Access Compliance Report

Public Rights-of-Way

(Pedestrian Signals)

Intersection ID: N/A	Main Street:	Cross Street: N/A	Location: N/A
ADA ID: FCD150CDE0DD	Signal Type: Two Push Buttons-Non APS	Overall Compliance: No	Severity Score: BTN 1:N/A BTN 2: N/A No BTN: N/A
Codes/Mitigation Info/Possible Solution		Field Measurements/Component Compliance

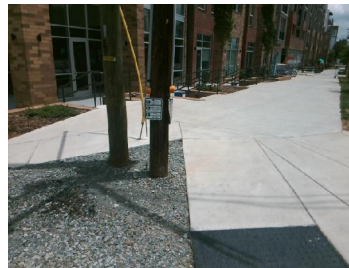
Surveyor Notes: TEXT HT 1/2

PROW/ADA: R410.6, R209.1, TMUTCD 4e.08, R404.2, R404.3, R406.2, R404.1, R404.7.1, R404.7.2

Possible Solutions: Remove & Replace Sign. Provide Push Button Extension. Remove and Replace Clear Space. Remove & Replace Crossing Striping. Provide Clear Space.
